Aladdin's Castle® Memo

TO: ALL MANAGERS
FROM: TECHNICAL SERVICE DEPARTMENT
RE: GREMLIN "SPACE FURY" MODIFICATION/RECALL

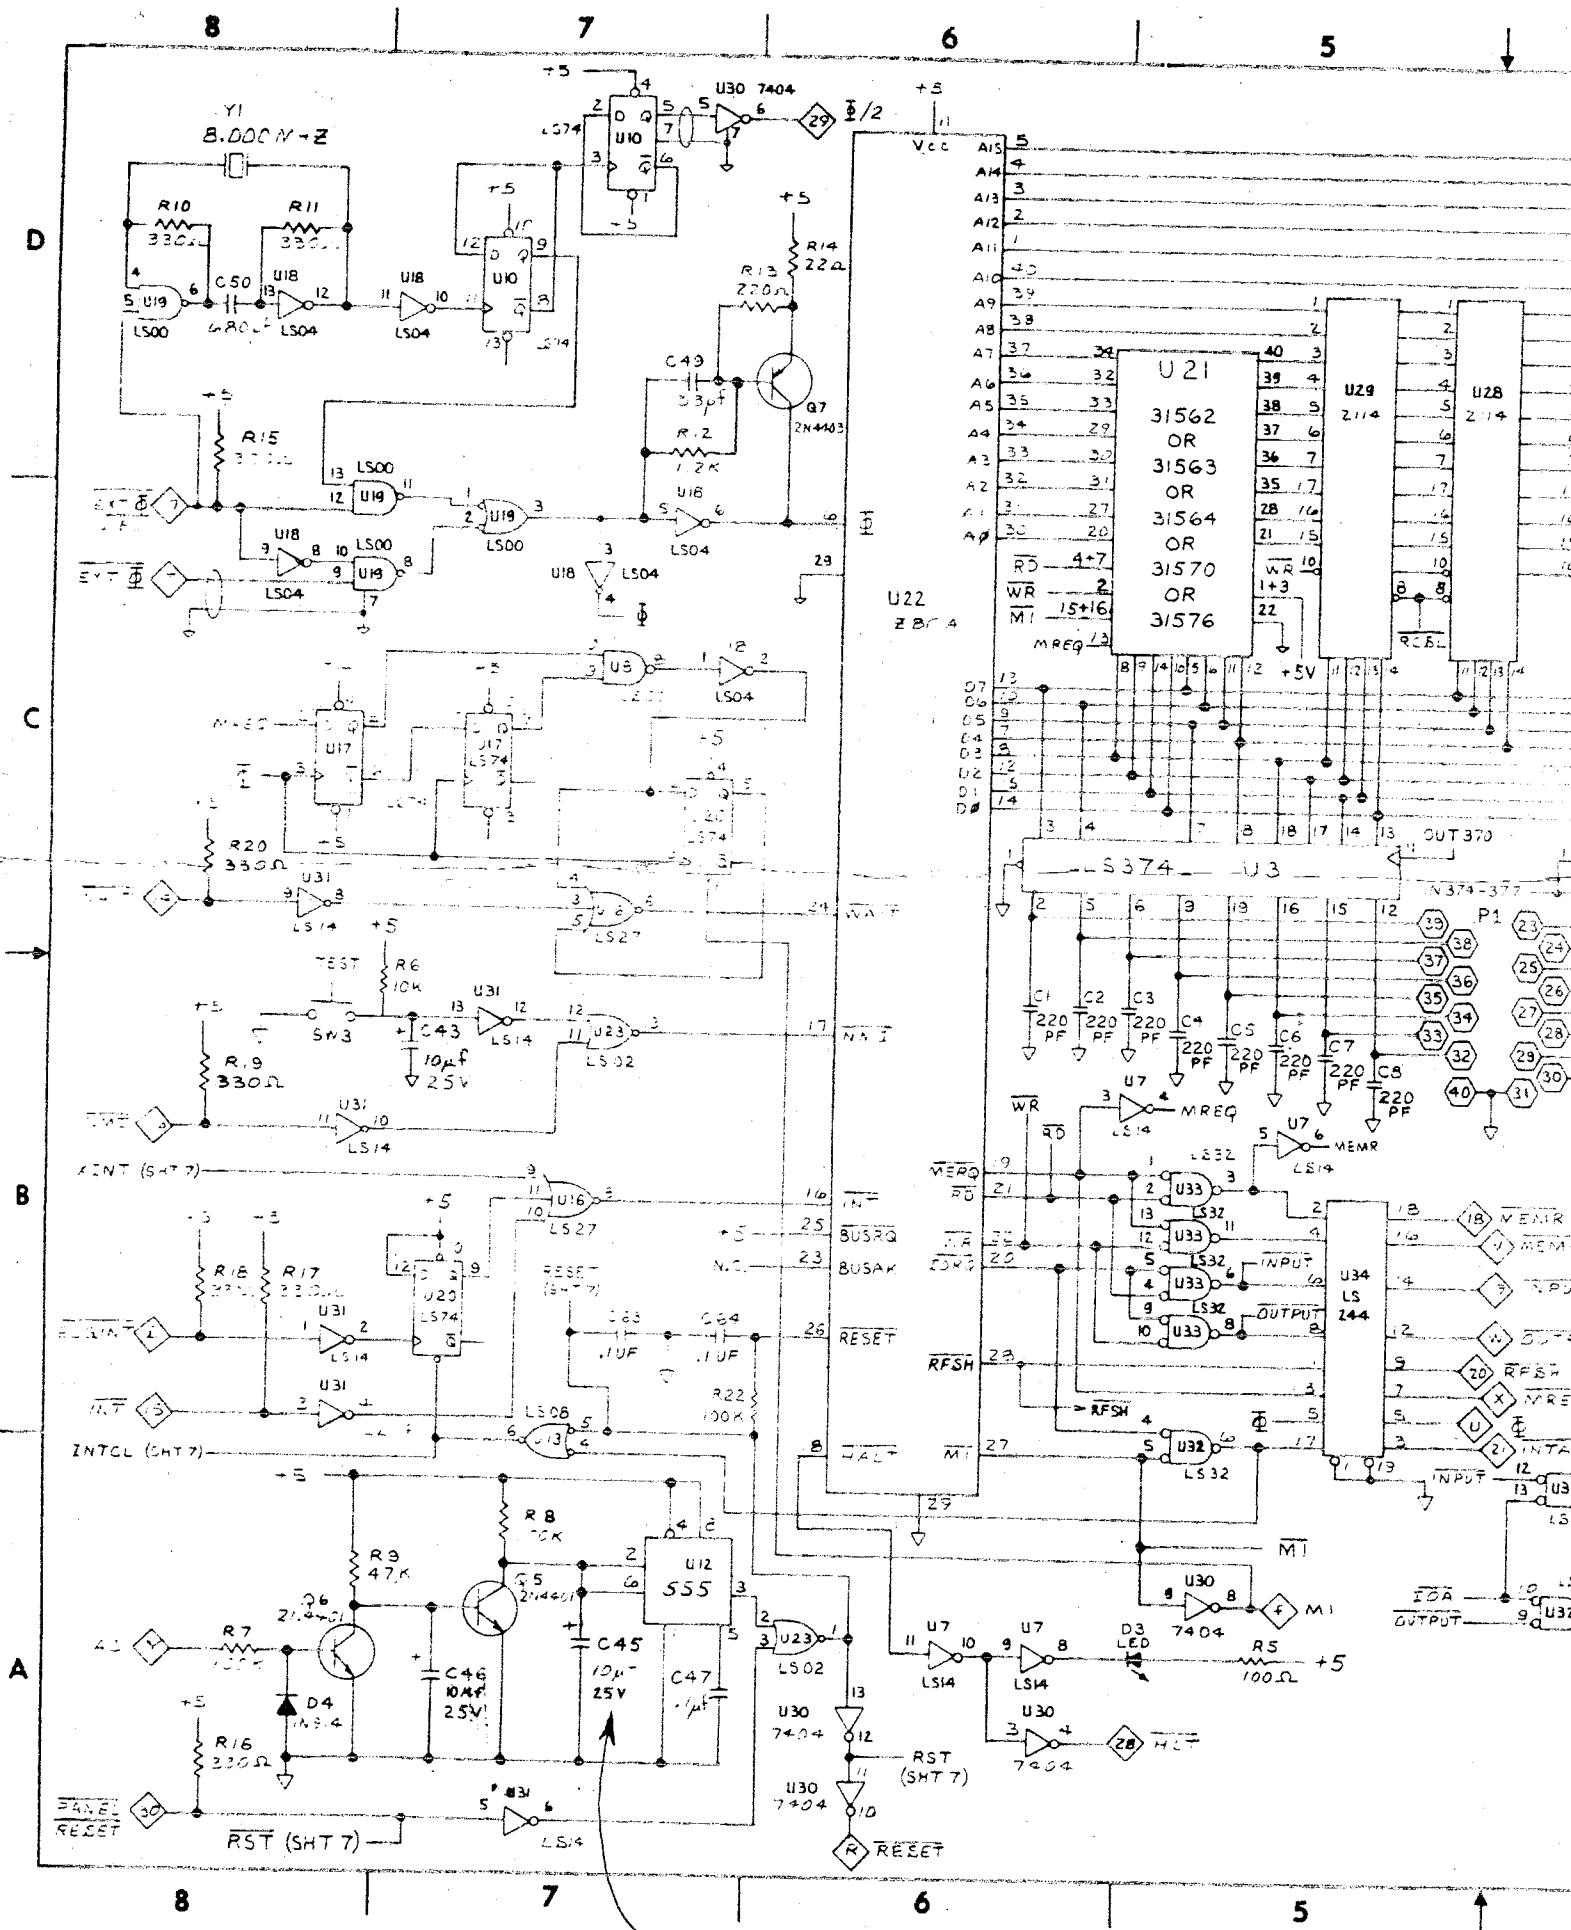
add IN914
or
IN4148

C45 must be changed to .22 or .33 u
